City of Calgary  
Planning & Development

RE: File Number: LOC2018-0135; Followup from Mystic Ridge Resident Concern Letter of July 19, 2019

Figure 1. Mystic Ridge Community

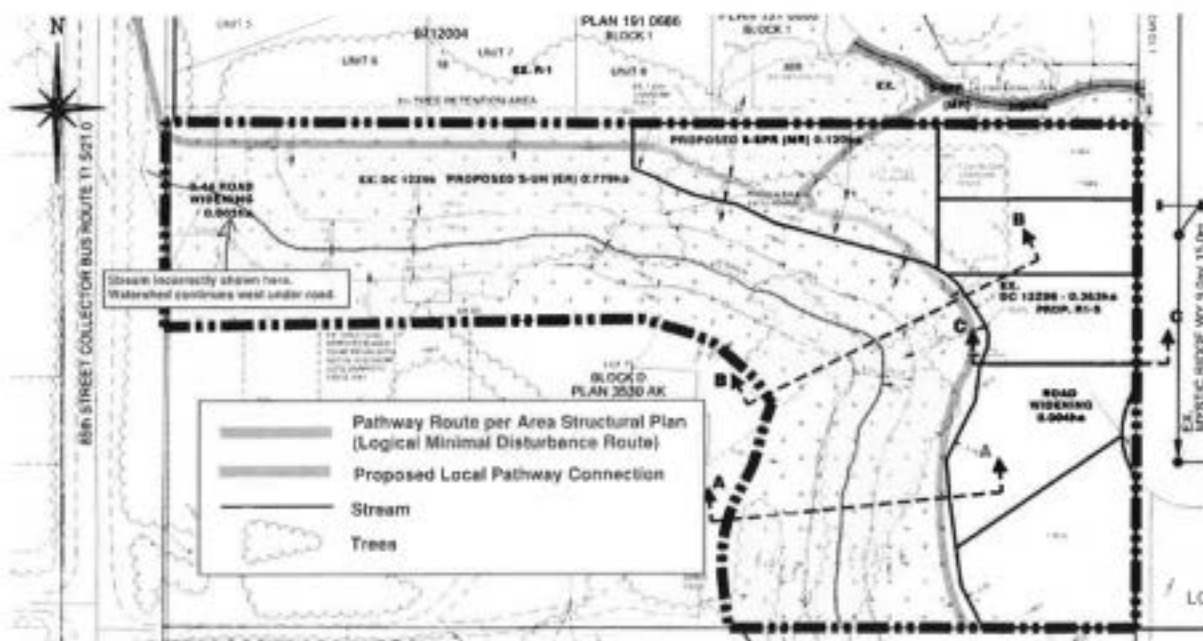
On July 19, 2018, a letter was sent to the city signed by 22 of 24 residences in Mystic Ridge. The residential lots of LOC2018-0135 is clearly within this community surrounded on three sides by the ravine (Figure 1). Mystic Ridge is an estate community that was developed by United Communities and Calbridge homes in 2012-2015. For whatever reason, the original Mystic Ridge zoning excluded the land in the subject application, leaving the street front available. As the current residents of this community, we request that this land be developed in a character and manner consistent with our existing community.

The number of 5 proposed lots is out of context with this neighborhood location. Mystic Ridge has a density close to 7 upha, which is within the guidelines set by the Springbank Hill ASP. If the number of applicant lots are reduced from 5 to 4 in the same space, the density results in about 8 upha which is also within the guidelines and is more consistent with our community.

In particular, these lots reside along 70m of street front. With 5 lots, the average house frontage calculates to 14m. Existing residential lots directly across the street have a 25m frontage. The imbalance will result in congestion conflicts from driveways and parking along the southwest corner of Mystic Ridge Way. With the preferred 4 lots, the frontage calculates to an average 17.5m which is more acceptable.
